# **Bell Helicopter** **TEXTRON**

**INFORMATION LETTER** 212-05-57  
412-05-57  
412CF-05-18

**SUBJECT: CREW SEATS P/N 412-070-810-ALL: NOTIFICATION OF POSSIBLE DAMAGE TO SEAT ATTENUATOR GUIDE PIN P/N 222-620-821-101**

FIGURE 2: Observed damage to pin

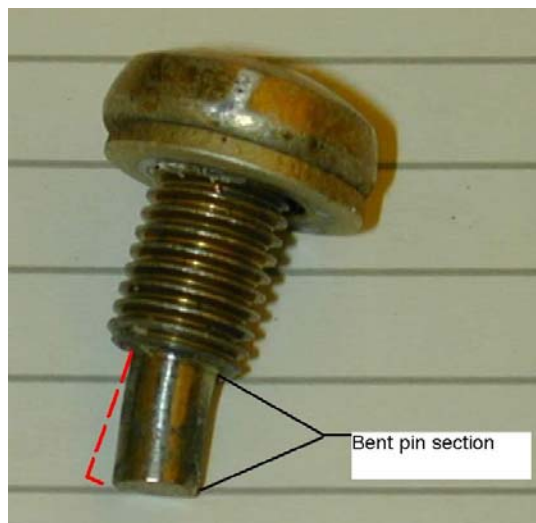
It has been brought to the attention of Bell Helicopter Textron that during an unscheduled inspection of a Bell 412 crew seat, the attenuator guide pin was found bent (see Figure 2).

This Information Letter is issued to remind all 412 operators that the adjustment of the crew seats vertical height without personnel controlling the upward motion (no weight on seat) will result in guide pin damage. The seat attenuator internal spring assists personnel when the seat vertical position is adjusted. The external guide pin P/N 222-620-821-101 will limit upward movement of the seat but damage will result if upward velocity is not controlled. The 412 maintenance manual warns operators to this effect.

The damage seen in Figure 2 was determined to have no effect on the attenuating capability of the seat. However, if heavy contact is suspected, pin should be removed, inspected and replaced as required.
